Magnolia Public Schools

Ad-Hoc (Facility) Committee Meeting

Approval of MSA-1 Owner Change Orders No. 6 and No. 7

Ad Hoc Committee Agenda Item #:	III.A.—Action Item
Date:	June 3, 2019
To:	Magnolia Educational & Research Foundation dba Magnolia Public Schools (“ MPS ”) Ad Hoc Committee (the “ Committee ”)
From:	Alfredo Rubalcava, CEO & Superintendent
Staff Lead:	Patrick Ontiveros, General Counsel & Director of Facilities
RE:	MSA-1 Change Order Requests 6 and 7

1 BUILDING SECTION
S4.0
SCALE: 1/4"=1'-0"
NOTES:
1. FOR INFORMATION NOT SHOWN SEE ARCH'L PLANS SECTION 1/AS.1
2. ELEVATION TO BE VERIFIED W/ARCH'L PLANS
3. FOR JOISTS/BEAMS/DECK DIRECTION SEE PLANS

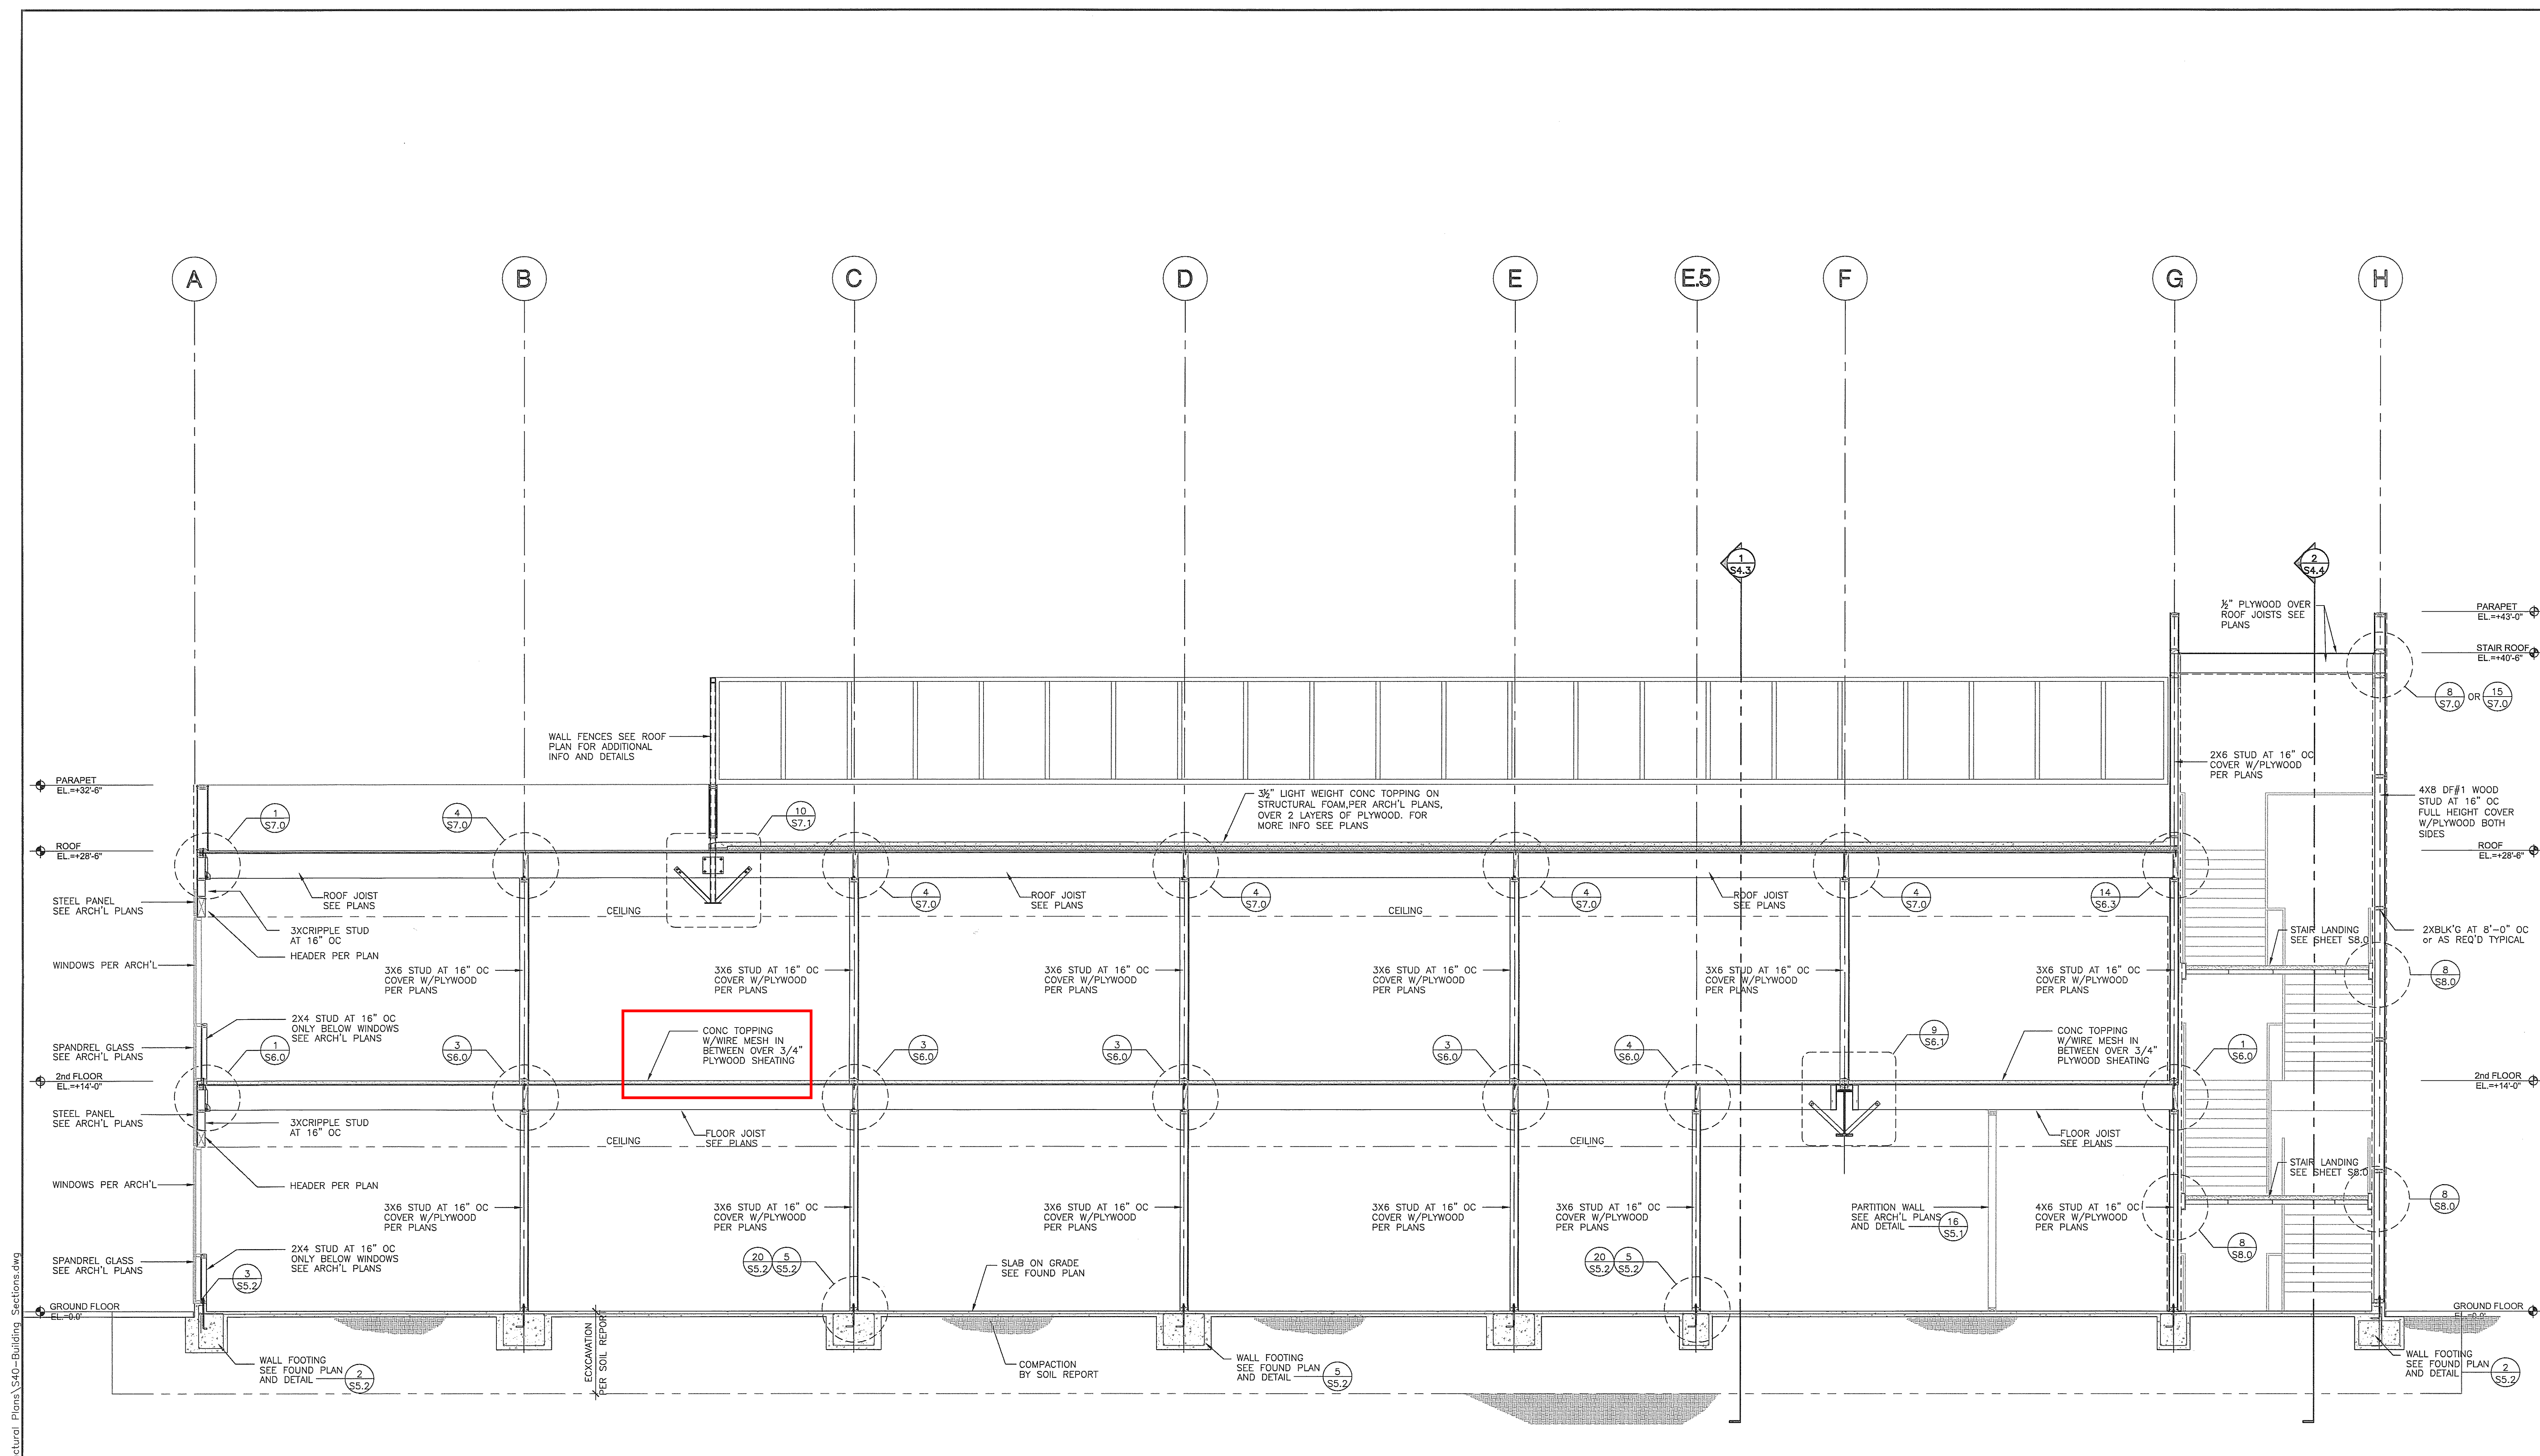
Refer to: S4.0

1. The concrete topping on 2nd floor over plywood is not a standard decking detail and we would like to ensure we are meeting design intent and general functionality.
 - a. Please confirm the +/-2.5" concrete topping slab (4000psi) over ¾" plywood on the 2nd floor is to receive wire mesh per S4.0.
 - b. Please confirm there is NO relief/soft cuts required for this slab.
 - c. Please advise if there are any pre-loading or shoring requirements for the 2nd floor and rooftop decks.

Response to RFI #062 states concrete topping slab to receive wire mesh per note 1 on S2.0. Per OAC meeting on 9/5/2018, owner has requested **fiberglass mesh in lieu of wire mesh.** Please provide a specification for fiberglass mesh.

1. The floor joists and plywood are designed to support the light weight concrete topping.
 - a. Please make sure the concrete is LIGHT WEIGHT CONCRETE. The concrete topping slab receives wire mesh per notes 1 on sheet S2.0.
 - b. No relief/soft cuts is required
 - c. No pre-loading or shoring is required. The plywood and roof/floor framing is designed to support the extra concrete weight. Please make sure all the roof/floor framing and diaphragm are constructed per approved structural set first. Then the concrete topping can be constructed.
